City Planning Commission Meeting
Tuesday, January 27, 2014

PRLIMINARY STAFF REPORT

To: City Planning Commission
Design Review: 166/14

DR 166-14

Maestri Condos 749-51 St Charles Ave

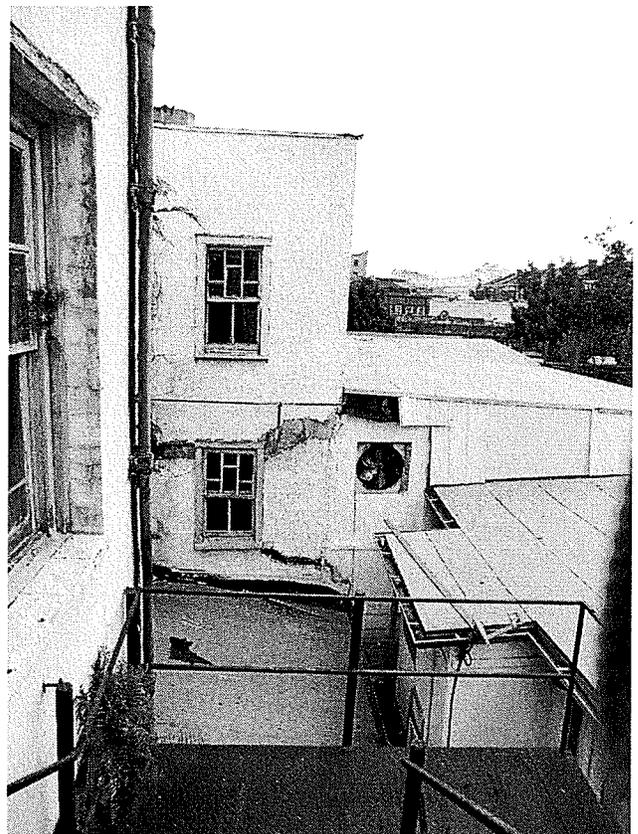
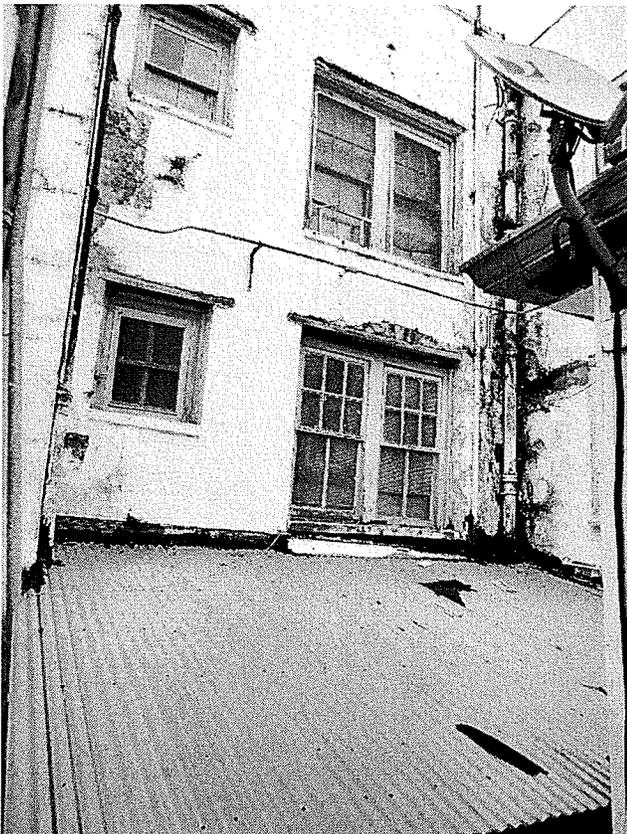
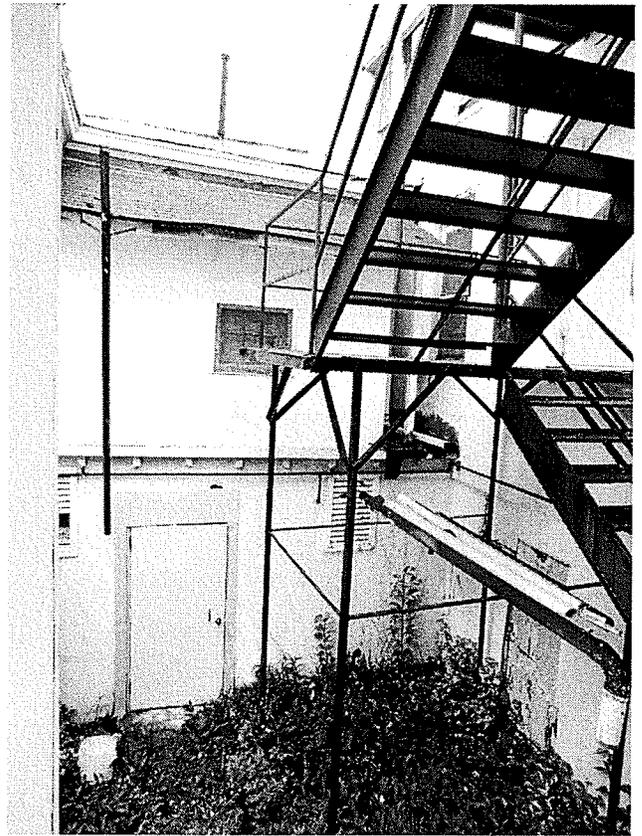
- The glass guardrails are incongruous with the materials of the historic building and the historical reference of the new construction. The guardrails should be metal.

- The guardrail at the top of the rooftop addition to the historic building should be setback from the parapet in accordance with HDLC Guidelines.
- The guardrail on the balcony needs further study.

- The balcony on the existing building appears to be drawn differently in the elevations and the rendering; the height of the balcony in the elevations is correct and the balconies of the existing building and the new construction should align.

- The mutin pattern of the doors at the 1st floor of the existing building to remain should reflect the appropriate historic typology.
- True stucco over historic masonry does not require control joints.

- On the rear (Carondelet St.) elevation, the sill height of the windows at the outside edges (where there is no balcony) should be raised to match the sill height of the windows at the center.
